**SAFETY
RECALL**

SR22-310

DATE :	August 2022	SECTION :	18 CHASSIS
SUBJECT:	USSC REAR BENCH SEAT BOLT MISSING

Figure1

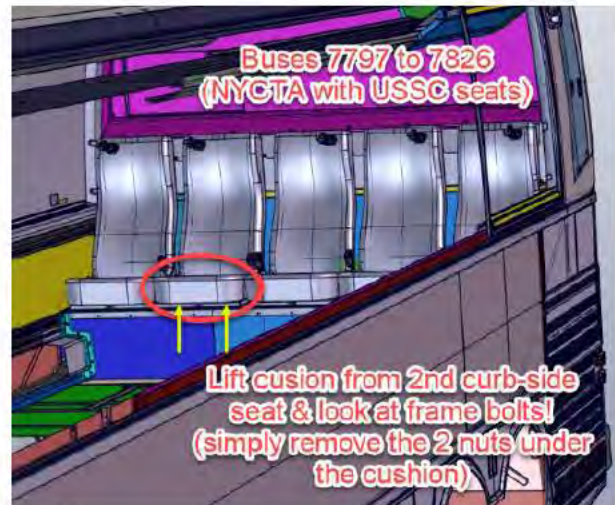
1. Remove the seat base from the 2nd curb side rear bench seat (red circle Figure1).

- Unscrew the two screws retaining the seat base to the frame (arrows Figure1).
- Lift to remove the base and expose the frame structure.

Figure2

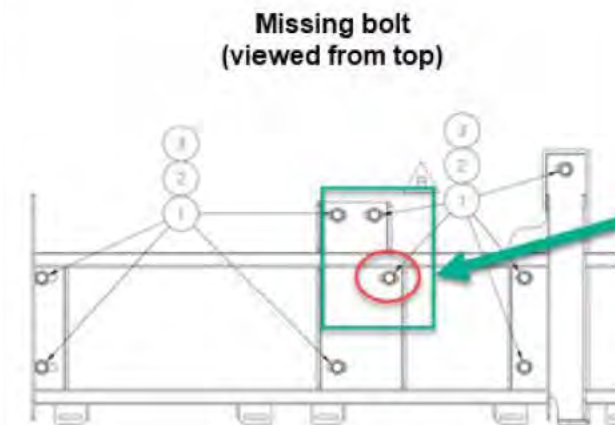
2. Locate the slot with a missing bolt in the rear seat base structure (red circle in Figure2).

Figure4

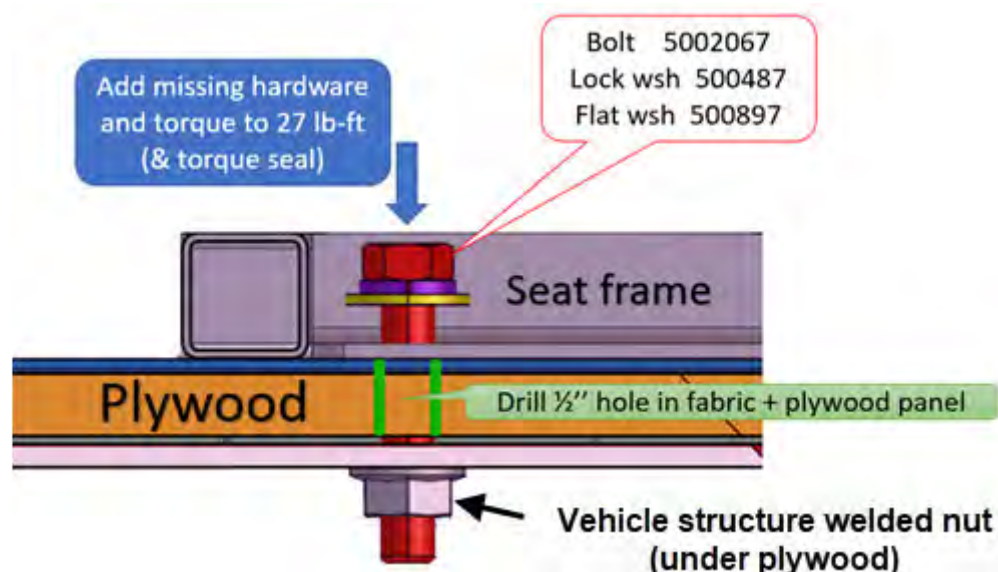
4. Install the missing bolt and hardware (Figure4).

- Install the supplied **5002067** Bolt, the **500487** lock washer and the **500897** flat washer.
- Torque the bolt to **27 lb-ft.**
- Add a strip of yellow Torque Seal indicator to the bolt head.
- Reinstall the seat base (Torque to **27 lb-ft**) to complete the procedure.
